COMBUSTION ENGINEERING

This is to request an amendment to the Model No. UNC-2901 shipping package to allow the optional use of ceramic sheet insulation to replace asbestos in the top and bottom of the drum. Enclosed is Drawing D-5007-8086, Rev. 4 and Drawing B-5007-8112, Rev. 1 showing this change.

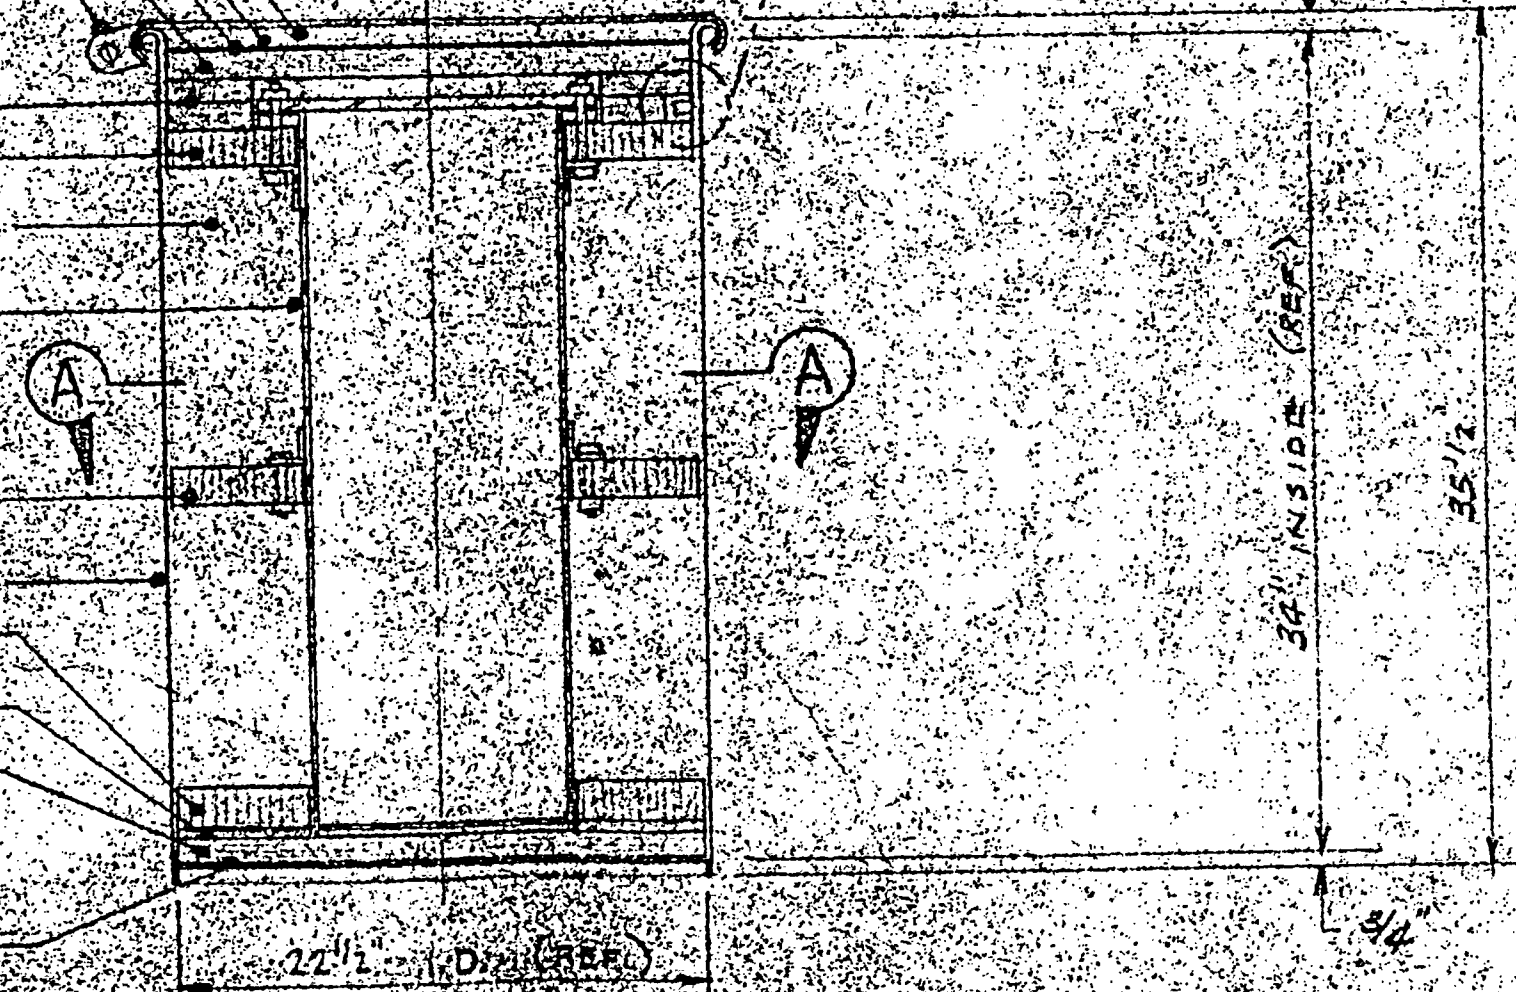
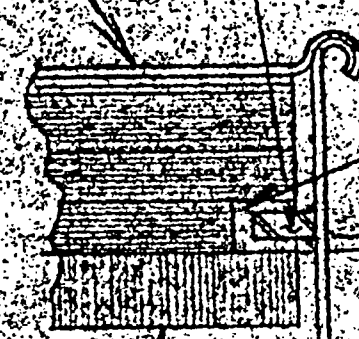
The flexible ceramic sheet will not burn and has better insulating properties than the asbestos sheet. The thermal conductivity of the ceramic is 0.38 btu/in/hr/°F/Ft², versus 1.15 for asbestos. Thus, this change will have no significant effect on the ability of the UNC-2901 package to meet the safety performance requirements of 10 CFR Part 71.

(B) ASBESTOS OR CERAMIC
 SHEET 1/8" THICK x 22" DIA.

ASBESTOS OR CERAMIC
 SHEET 1/8" THICK x 22" DIA.
